Appeal of Planning Commission Resolution No. 26-05 Regarding Coastal Development Permit No. 19-012 (25200 Pacific Coast Highway, APNs 4459-013-021 and 4459-014-018; Owner, PAR PCH, LLC; Appellant, Jun Hall for Concerned Citizens of Malibu Road, Inc.)

Malibu City Council
Special Meeting Agenda

Wednesday, August 19, 2026

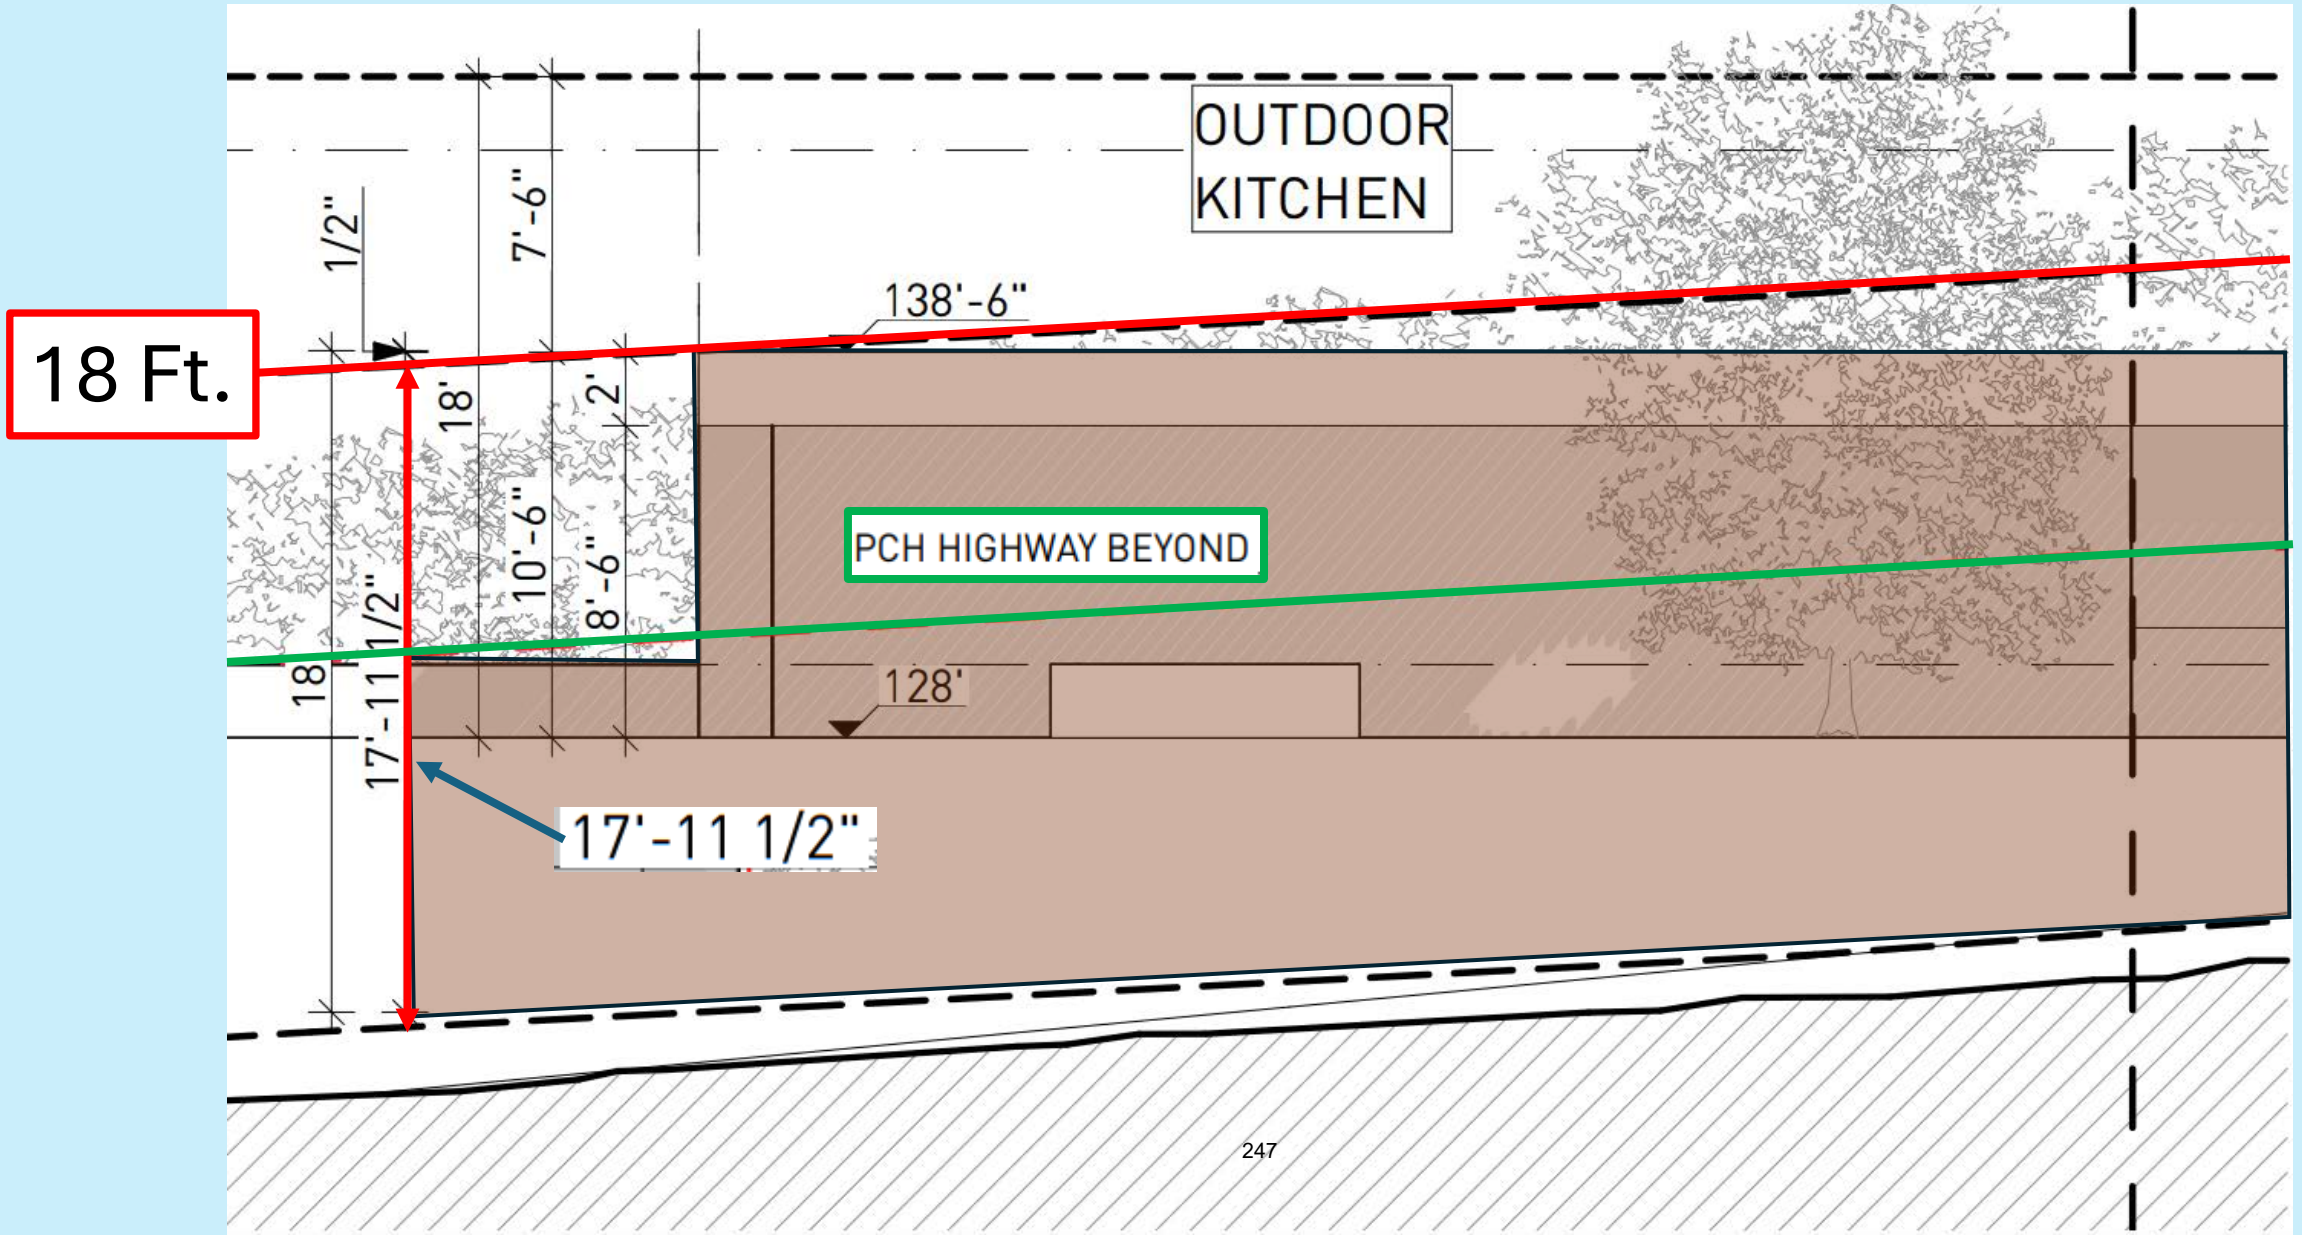
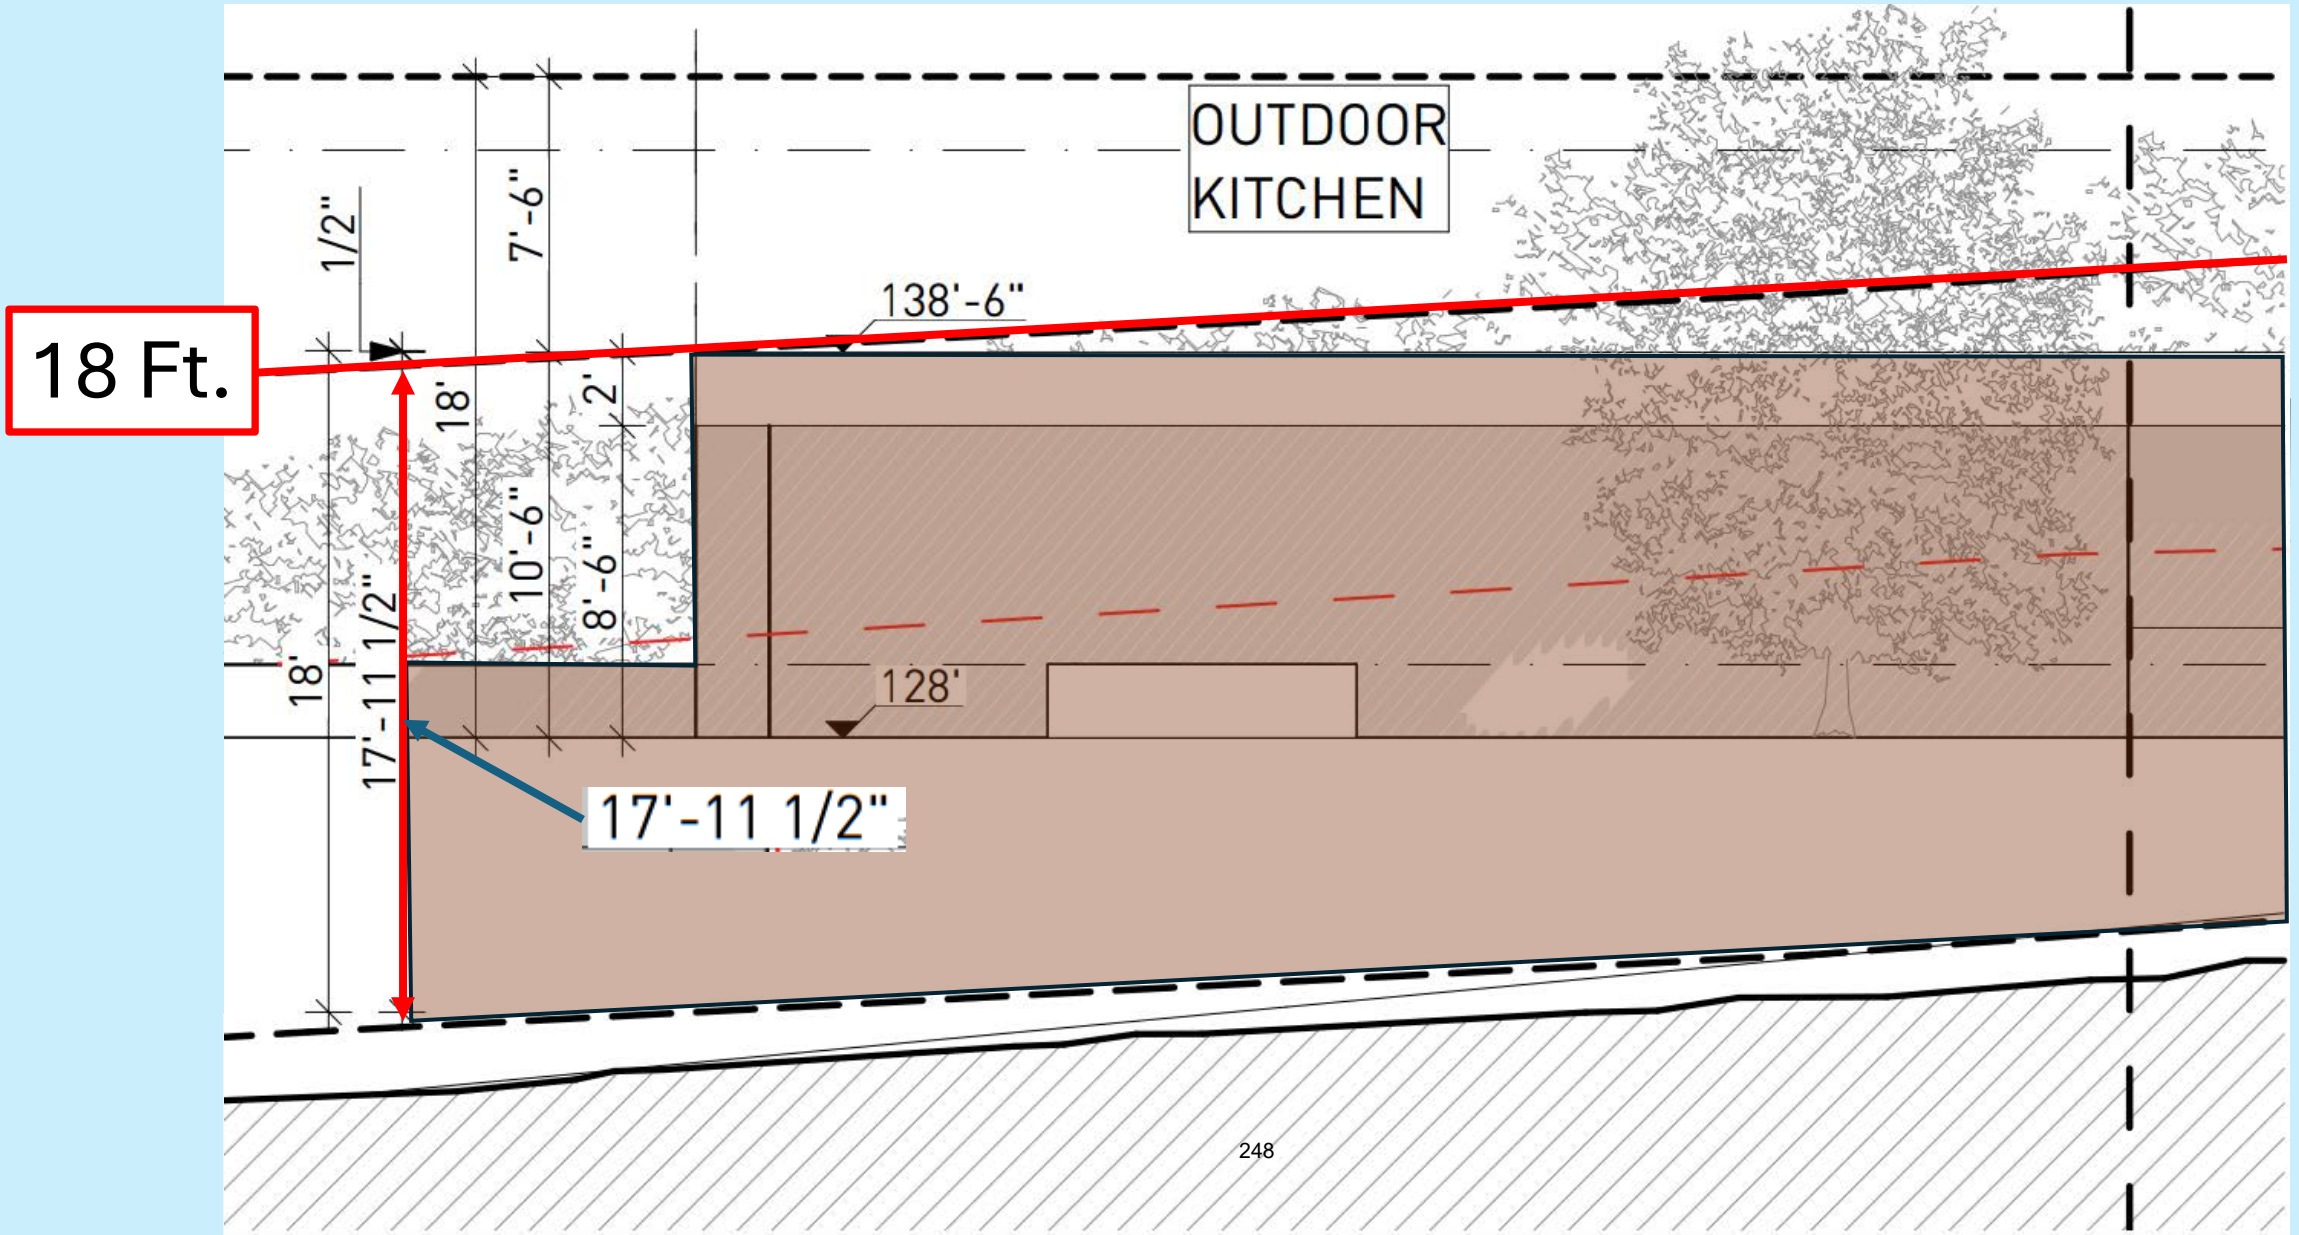
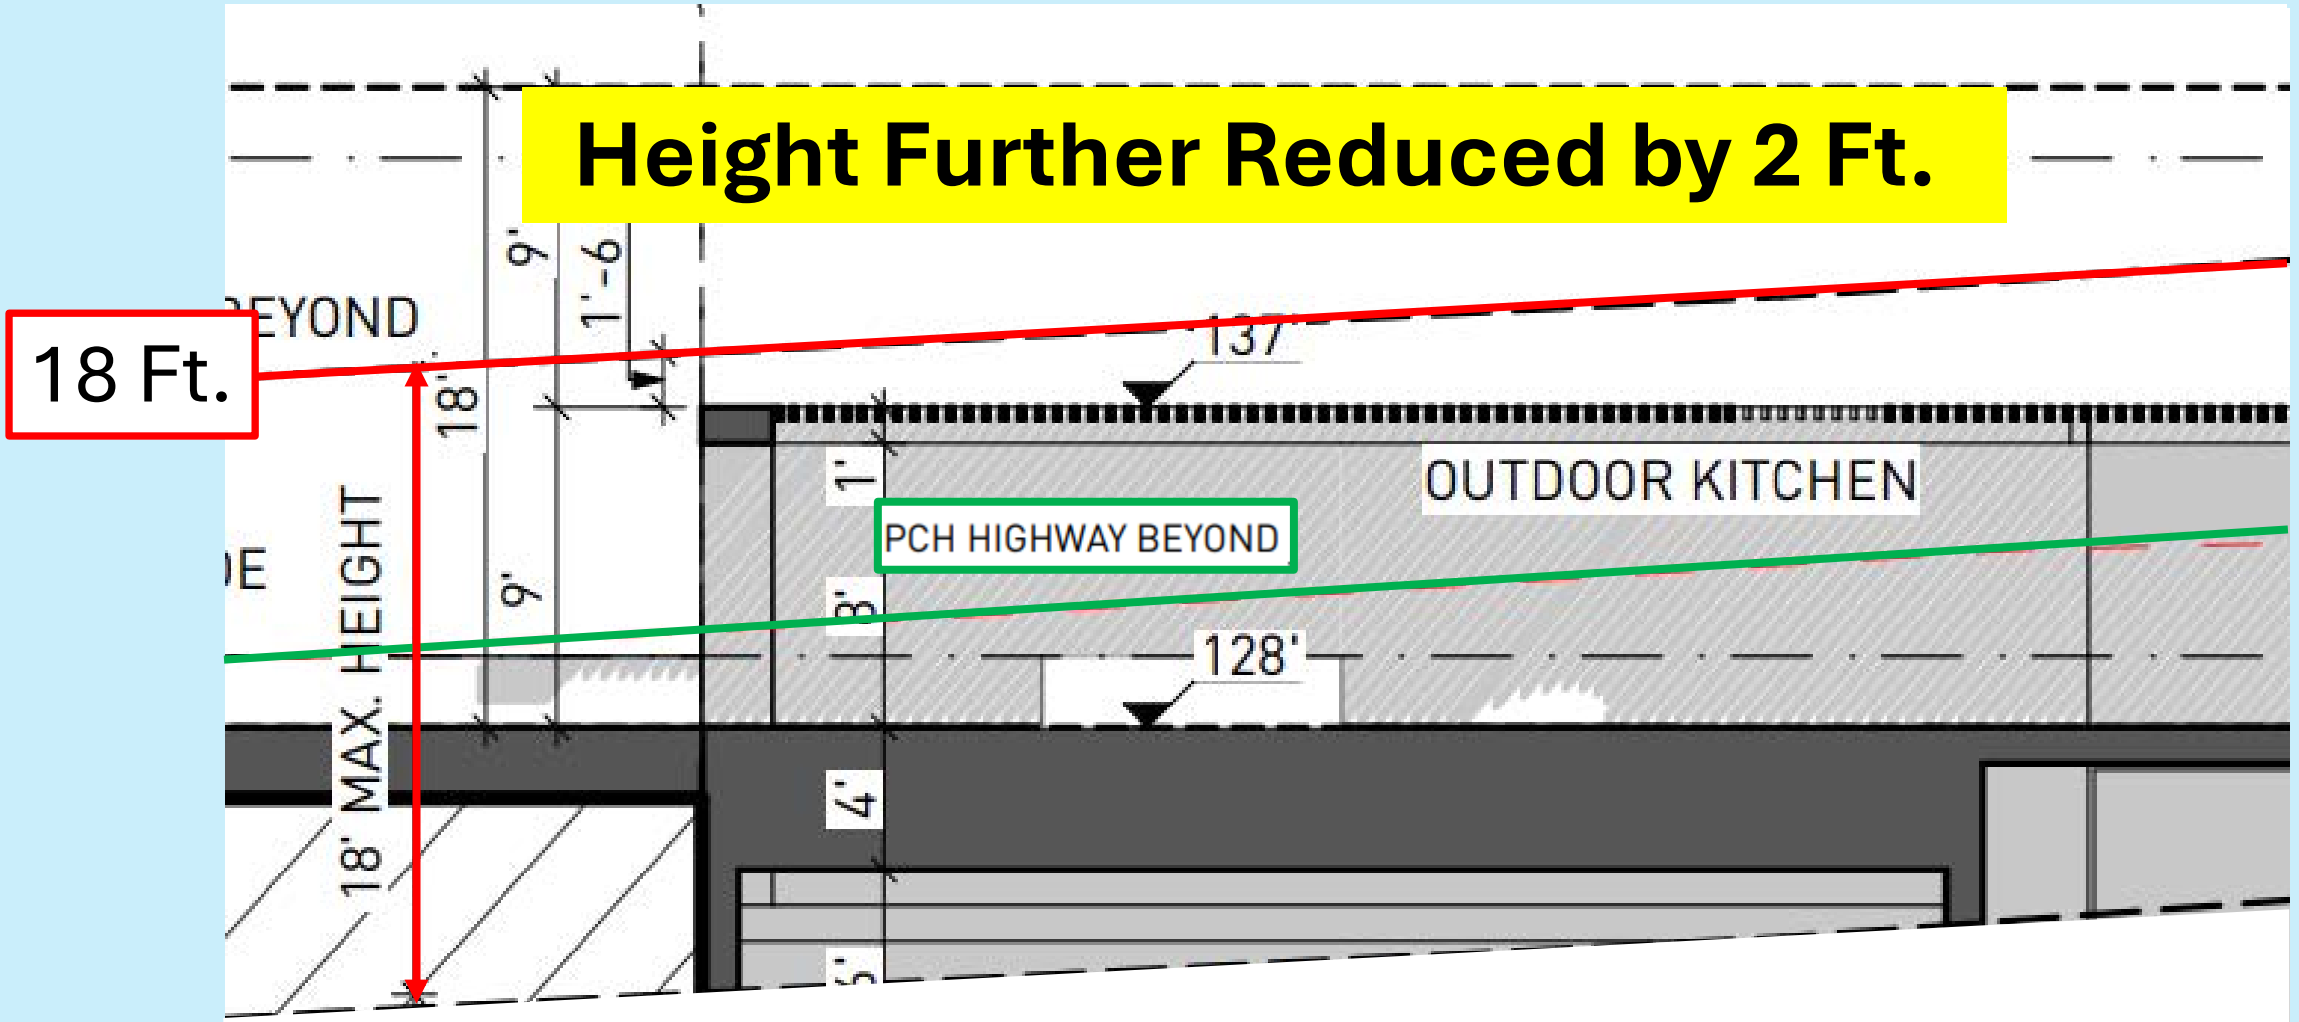
Outdoor Kitchen Originally 17ft., 11 in. Tall

Outdoor Kitchen Reduced to 16ft., 5.5 in. Tall

Outdoor Kitchen Reduced to 14ft., 6 in. Tall

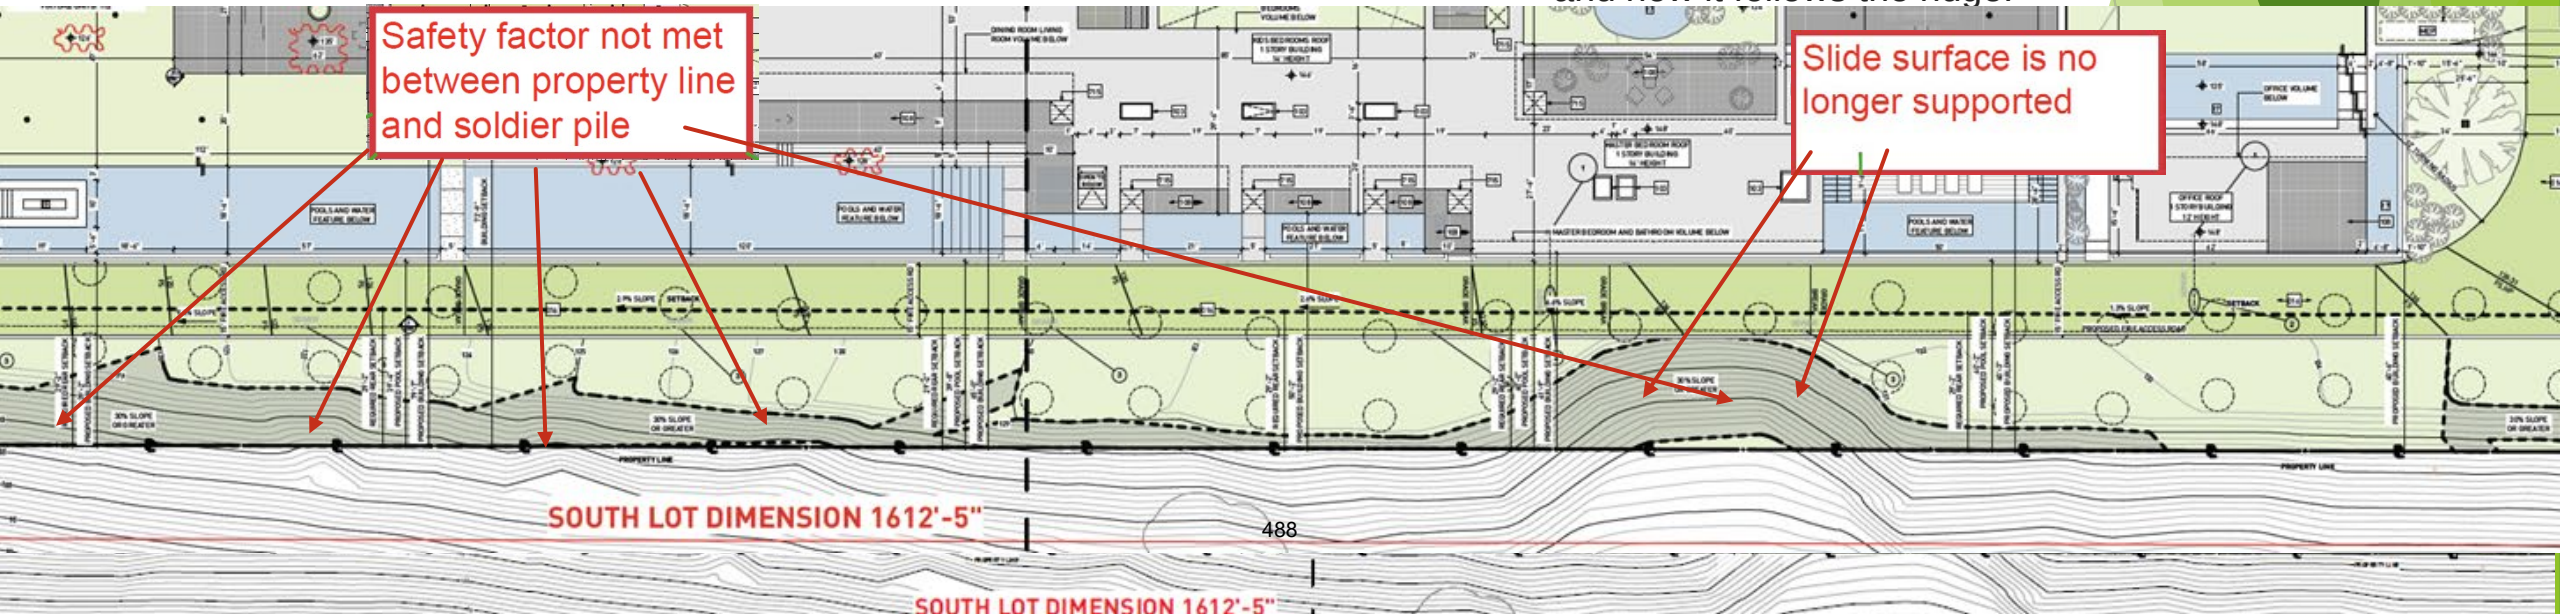
This is where the safety factor is clearly not met – They **moved/relocated** the soldier piles a few feet to avoid a slope variance and now they need a variance because there is space between the property line and the soldier piles where the safety factor is not met.

In addition, they are no longer supporting the slide in front of the MASTER area, and this would cause a slide into adjacent properties. This first image is before they moved the piles and shows the property line, it used to follow a straight line and now it follows the ridge.
